# TECHNICAL BULLETIN

[Issue No.] FA-A-0075

[Title] Production discontinuation of the AnS and QnAS series Ethernet interface modules

[Relevant Models] A1SJ71E71N-B2, A1SJ71E71N-B5, A1SJ71QE71N-B2, and A1SJ71QE71N-B5

(b) Replacement example

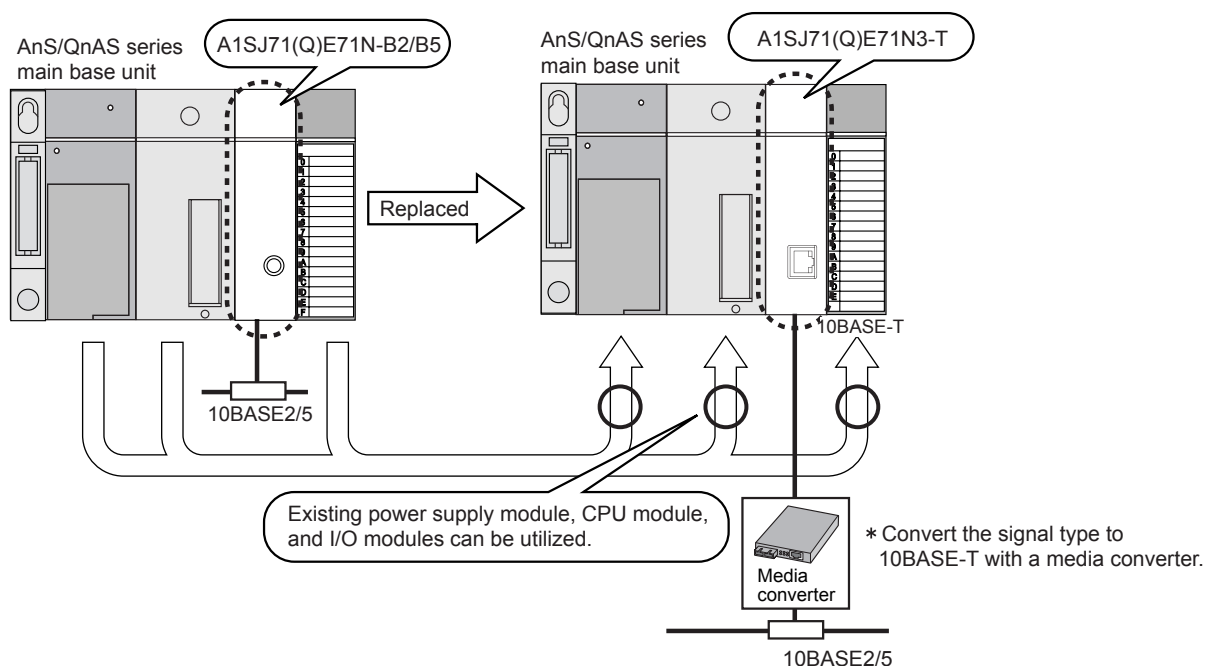
(1) Replacement with the same series models

Discontinued model		Alternative model
Series	Model	Model
AnS	A1SJ71E71N-B2	A1SJ71E71N3-T *1
	A1SJ71E71N-B5	
QnAS	A1SJ71QE71N-B2	A1SJ71QE71N3-T *1
	A1SJ71QE71N-B5

\*1 The signal type must be converted from 10BASE2/5 to 10BASE-T. Using a commercially available media converter that is compliant with IEEE802.3 standards, convert the signal type of the existing cable to 10BASE-T.

(b) An example of using existing modules except a discontinued model and a CPU module

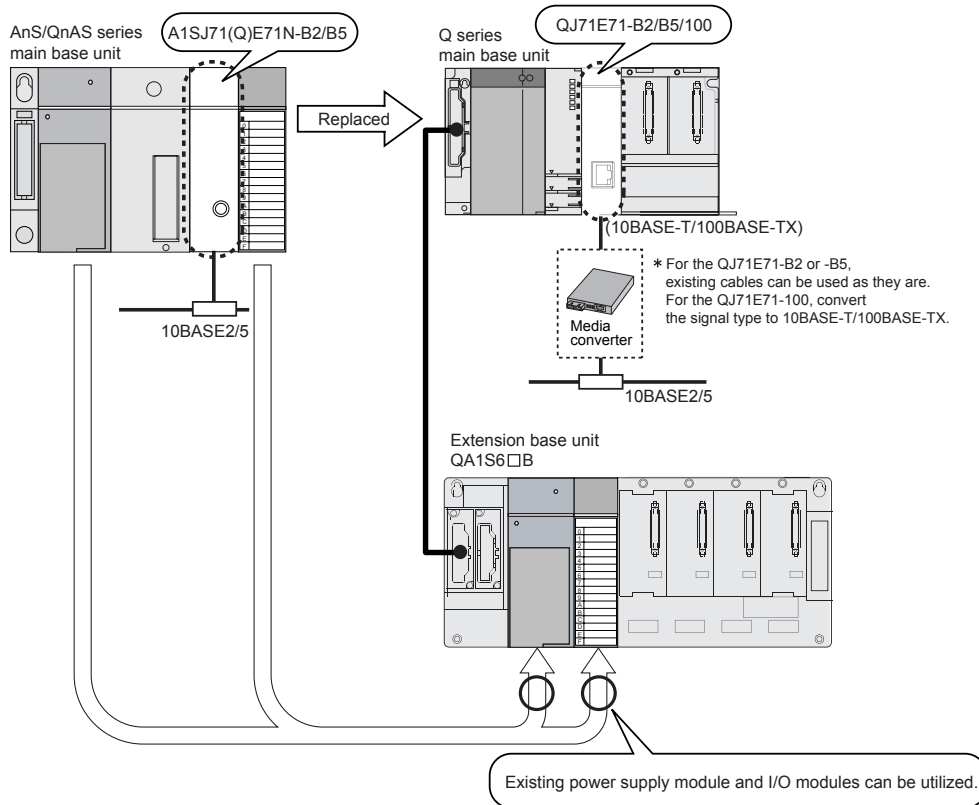
Note that, by using an extension base unit, QA1S6□B, the existing I/O modules can be used. (Refer to (b) in this section.)

For use of the QA1S6□B, there are restrictions on the CPU and other module models.

(c) An example of replacing all modules with Q series modules

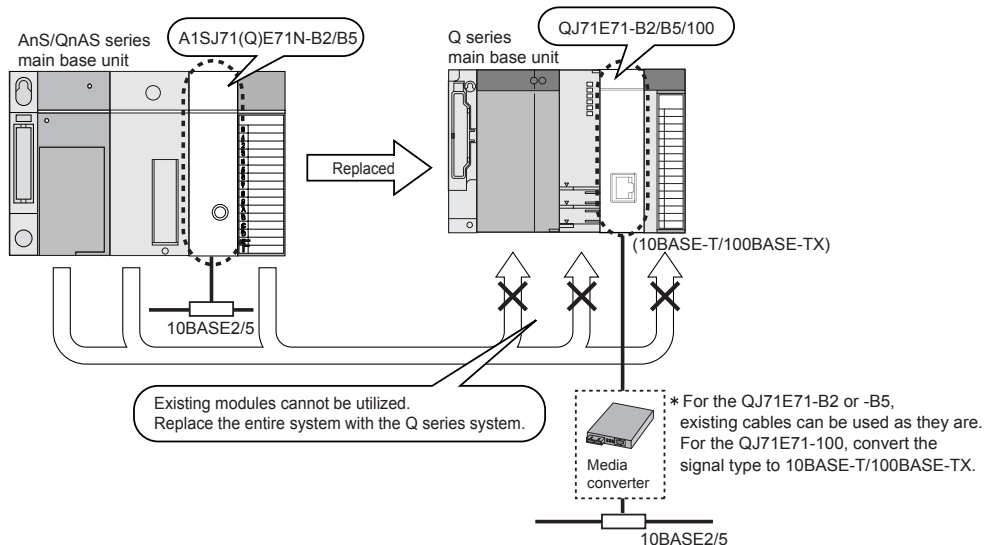
To replace a discontinued model with the QJ71E71-B2, -B5, or -100, the entire system must be changed to the Q series system. (Refer to (c) in this section.)
